RE: 1199 Congress Street

Your application to install 2 above ground tanks, 1-275 gallon and 1-500 gallon, has been reviewed and a permit is herewith issued subject to the following requirements:

PLOT PLAN

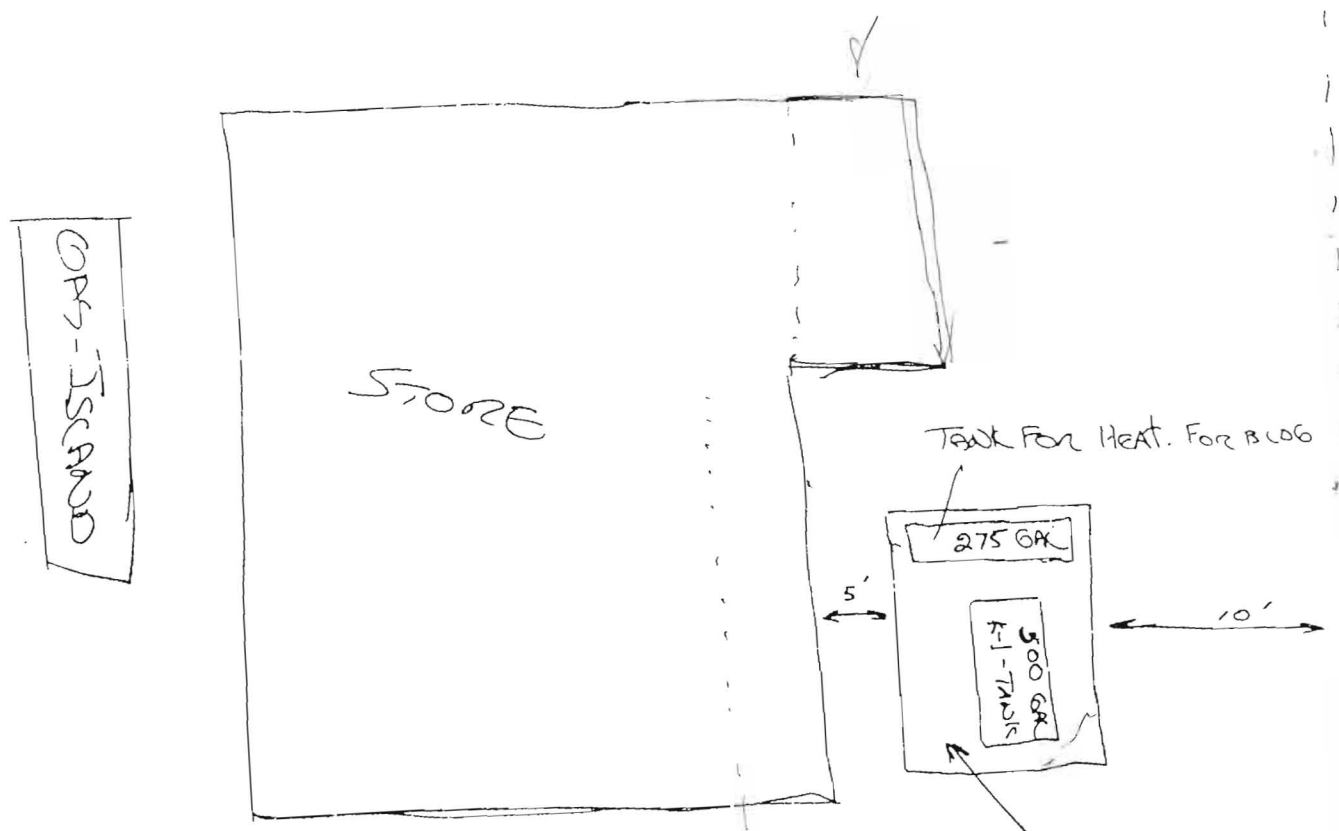
1. Proposed 775 gallon total, proposed storage exceeds that allowed within 10' of property line. Either storage volume must be reduced or installation moved to a point where 15' clearance of property may be met. Revised plans must be submitted.
2. Piping must be protected from mechanical damage through use of barriers to deny access to area of piping or bollards; to deny vehicle access.
3. Installation shall be in accordance with N.F.P.A. #30.
4. Area of tanks and piping shall be kept clear of vegetation and combustible debris or storage.
